#### **City Planning Department**

## Memo

Re: "Champlin Hills – Major Amendment"

Major amendment to a recorded Final Plan (5/5/17) **Preliminary Plan** - Major Land Development

# **SNIPPET OF SITE PLANS (Club House Amendment)**

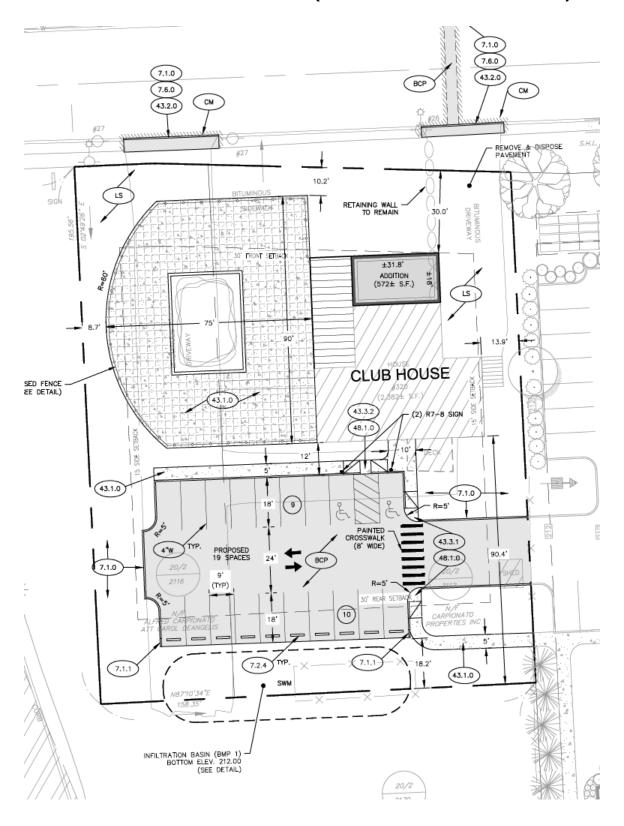
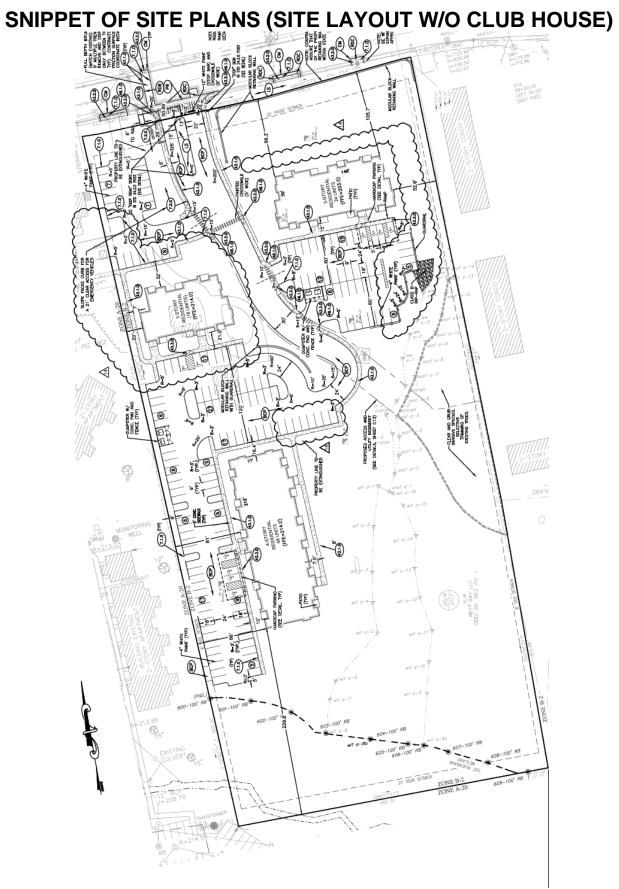
- 4. <u>Fire Department</u> Mr. James Woyciechiwski, Deputy Fire Chief responded in writing on 4/26/23 and stated that he was initially concerned about the Fire Department's ladder truck's ability to negotiate the turn to reach the four-story apartment building in the southern portion of the site. He further stated that after reviewing the most recent materials, he has no issue or concerns that would hinder fire department access to the apartment building.
- 5. <u>Building and Zoning Department</u> Mr. Stan Pikul reviewed the major amendment with the DPRC on 4/19/23 and had no specific concerns. He stated that the applicant is required to obtain the dimensional relief for the new building's height as well as the use variance for the clubhouse relocation to the A-20 portion of the property.
